ADDRESS : 56 FARRAH-SHEA WAY  
 CONTRACTOR : CUMBERLAND HOMES INC  
 OWNER : BARCO DEVELOPMENT INC  
 PARCEL : 04-0662- - -0024- -22-  
 APPL NUMBER: 16-50039488 CP NEW RESIDENTIAL (SFD)  
 DIRECTIONS : T/S: 08/16/2016 09:20 AM JBROCK ----  
 FARRAH SHEA WAY LOT 18  
 BRIAN KEITH MEADOWS

**STRUCTURE: 000 000 56X40 3BDR SLAB W/ GARAGE**

**GDH Kerto-S LVL 1.750" X 11.875" 2-Ply - PASSED**

COMMENTS AND NOTES

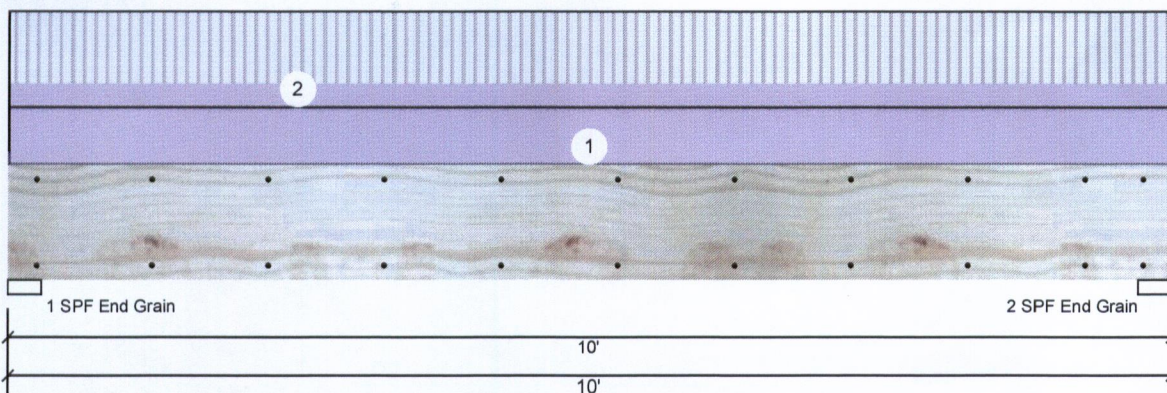
R425 01	2/08/17 2/08/17	BS DA	FOUR TRADE ROUGH IN TIME: 17:00 VRU #: 002930394 T/S: 02/07/2017 10:49 AM DJOHNSON ----- T/S: February 08, 2017 01:18 PM BSUTTON ----- 1. Plan calls for 2-16 inch LVL over garage wall. 2-11/7/8 installed. 2. Need structural nail plate at 1/2 bath lav vent at top plate. 3. Improper Uplift at girder truss BGR-2PLY left side. 4. Window missing at bathroom up. 5. Foam seal HVAC ducts top and bottom at second floor chase. OK to side/insulate
R425 02	2/15/17 <u>2/15/17</u>	TI <u>DABS</u>	FOUR TRADE ROUGH IN TIME: 17:00 VRU #: 002933695 T/S: 02/14/2017 02:13 PM JBROCK -----

Analysis	Actual	Location	Allowed	Capacity	Comb.	Case
Moment	6194 ft-lb	5'	19911 ft-lb	0.311 (31%)	D+L	L
Unbraced	6194 ft-lb	5'	9628 ft-lb	0.643 (64%)	D+L	L
Shear	2058 lb	1'2 5/8"	8867 lb	0.232 (23%)	D+L	L
LL Defl inch	0.056 (L/2051)	5'	0.239 (L/480)	0.230 (23%)	L	L
TL Defl inch	0.121 (L/946)	5'	0.318 (L/360)	0.380 (38%)	D+L	L
